Ian T. Cole

March 8, 2021

RE: Wetland Analysis – Lee Winakor, 2021 Wetland Application for Shoreline Improvements to 24 Island Road, Assessor’s ID 45-8000, North Stonington, Connecticut.

Figure 4: Visual Simulation of Proposed Activities

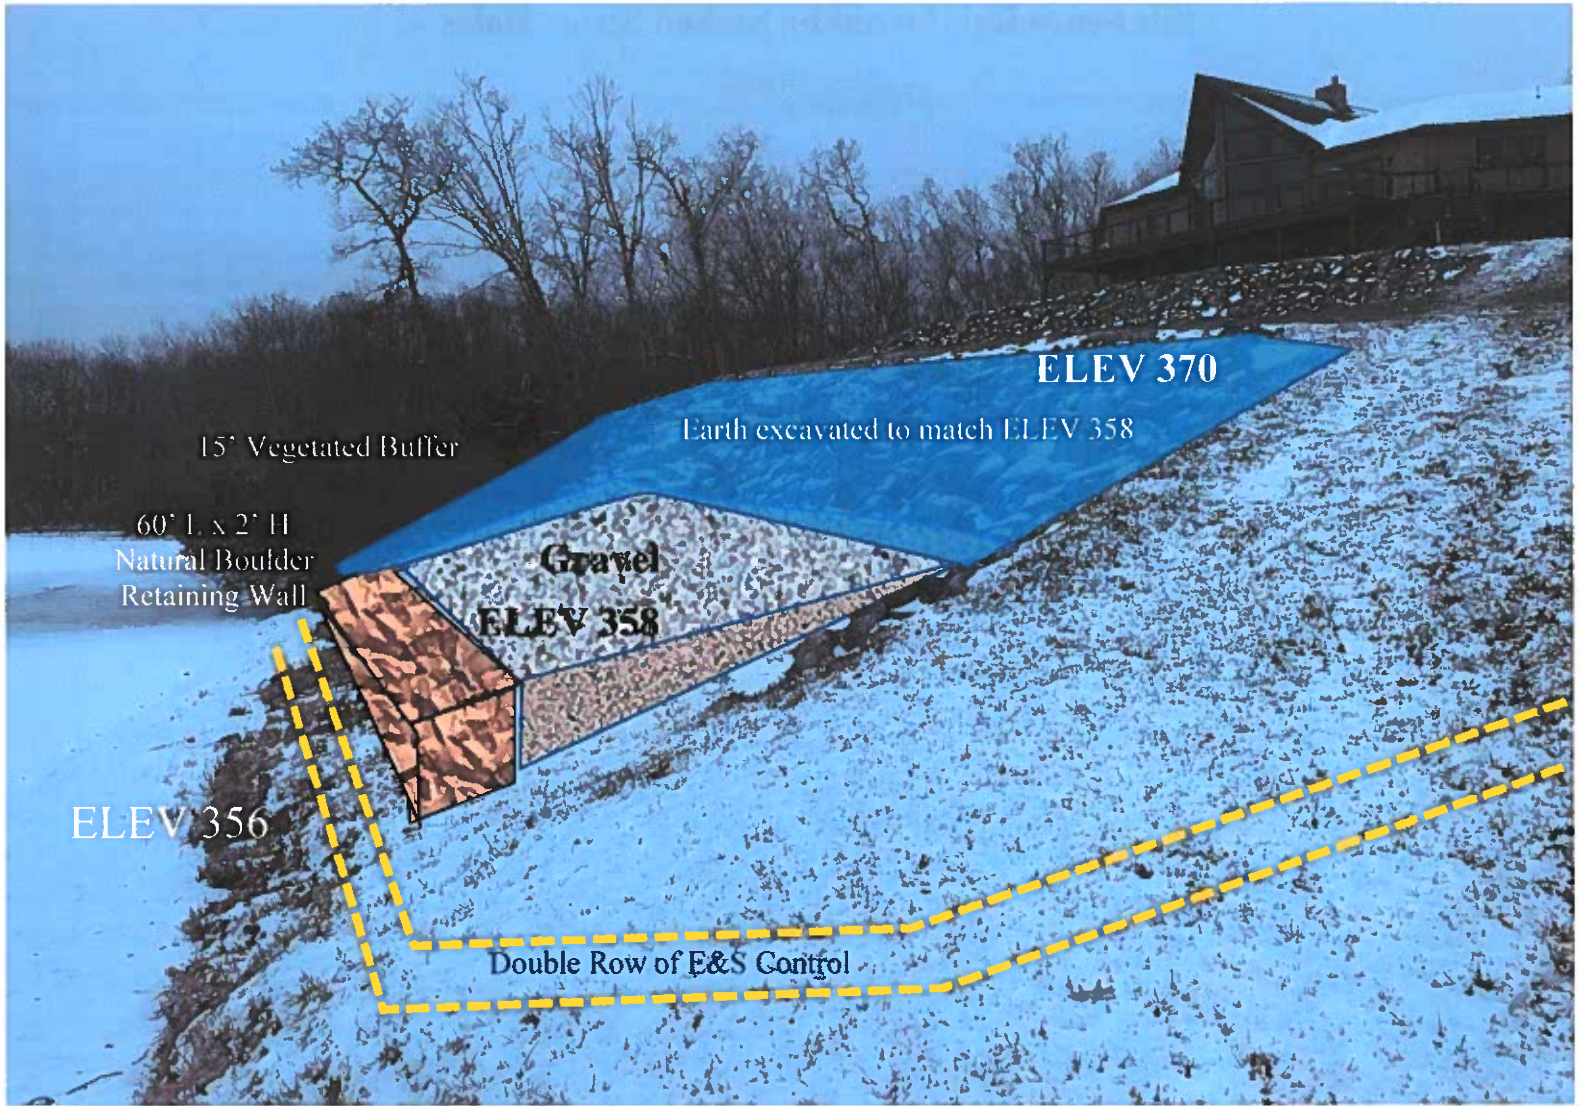
The applicant is seeking approval from the Town of North Stonington to add improvements to the shoreline of Billings Lake. The proposal includes modifying the existing man-made terraced landscape to provide a more usable lakeside area. In addition to the applicant’s provided site plans, the attached Figure 2 and Figure 4 illustrates the general locations of the proposed activities which include:

1. Maintain a natural 15’ wide vegetated buffer along the shoreline.
2. Prior to the start of construction, a double row of silt fence backed by conservation haybales will be staked at grade along the limits of disturbance to provide erosion and sediment controls as well as a physical barrier to mark the limits of excavation. Additionally, as needed the silt fence will be backed by Snow Fencing to ensure no boulders escape the work zone. See details in Figure 5
3. Install a 60’ +/- long natural boulder retaining wall along the existing sand beach with boulders unearthed during excavation. The retaining wall will minimize the footprint of grading along the existing beach shoreline and will provide excellent stabilization at the toe-of-slope.

4. Extend the existing lower terraced landing approximately 120' south along the shoreline.
5. Within the red boxed highlighted area shown on Figure 2 below, a heavy equipment operator in controlled phases will excavate the ground to match the lower terraced elevation or until Ledge is exposed. There is a 12' elevation change. The upper terrace would be excavated from elevation 370 down to approximately elevation 358.

Figure 5: Erosion and Sediment Control Detail

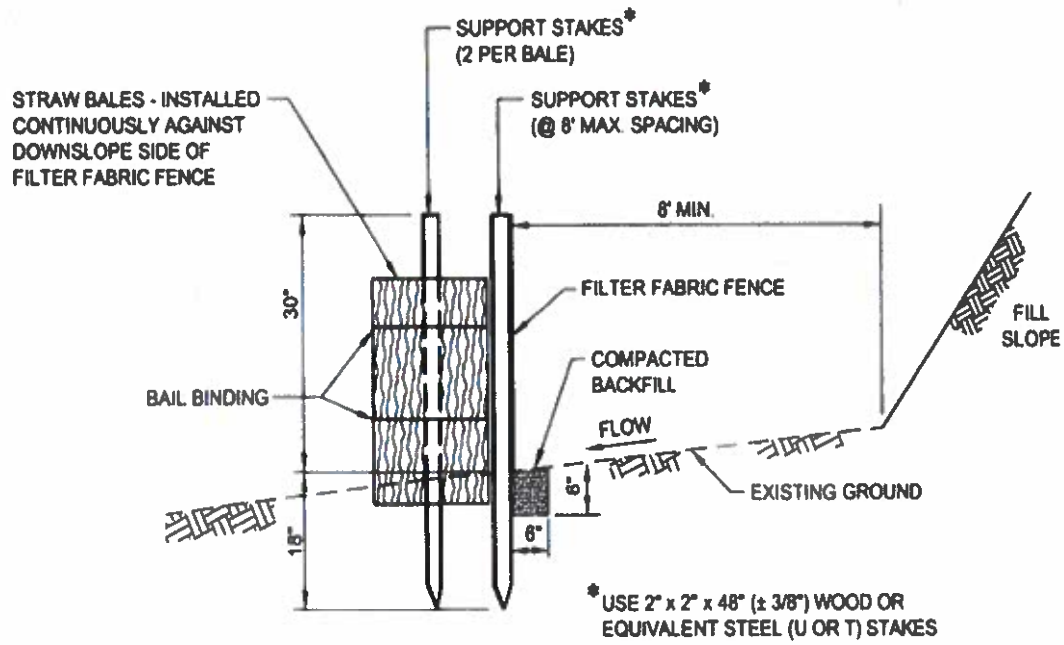
Short-term impacts during construction will be reduced through measures to control sedimentation and erosion. These measures will minimize the chance that siltation and sedimentation will encroach beyond the limits of disturbance or into the regulated wetlands. These controls as well as compliance with the state and local regulations and permit approvals will assure that no permanent adverse effects will impact the receiving wetlands or wildlife habitat. As the proposal does not include any direct wetland impact, and the activity of constructing a terraced the landscape is inherently an engineered solution to reduce the risk of erosion and minimize runoff, no secondary effects are anticipated to have an adverse effect on the wetlands and watercourses.
